From: Harris, Paul - Oxfordshire County Council
Sent: 05 April 2022 14:55
To: Catcheside, Emily - Oxfordshire County Council
Cc: Hamer, Katherine - Oxfordshire County Council
Subject: HIF1 Planning Application Comments (Public Rights of Way)

Highways GA sheet-specific comments

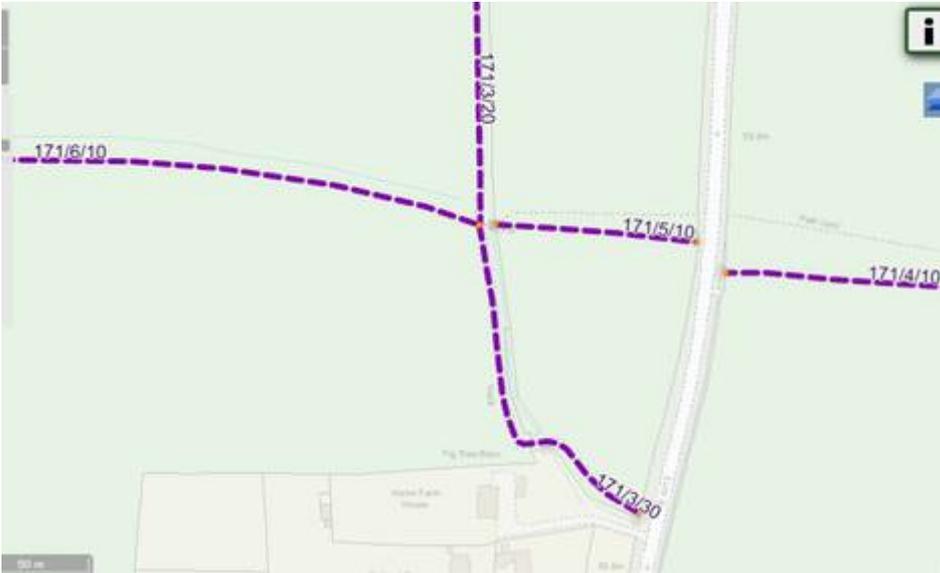
15. Highways GA/Landscape Sheet 12 (image extract below): Access for cyclists between Sutton Courtenay and Appleford Station should be made easy as a result of this road development. I am concerned that a shared used cycleway is provided the whole way – this could use suitable PRow if there was not the space on the B4016 road, subject to permissions. There needs to be user controlled crossings at all points so that NMUs have priority.
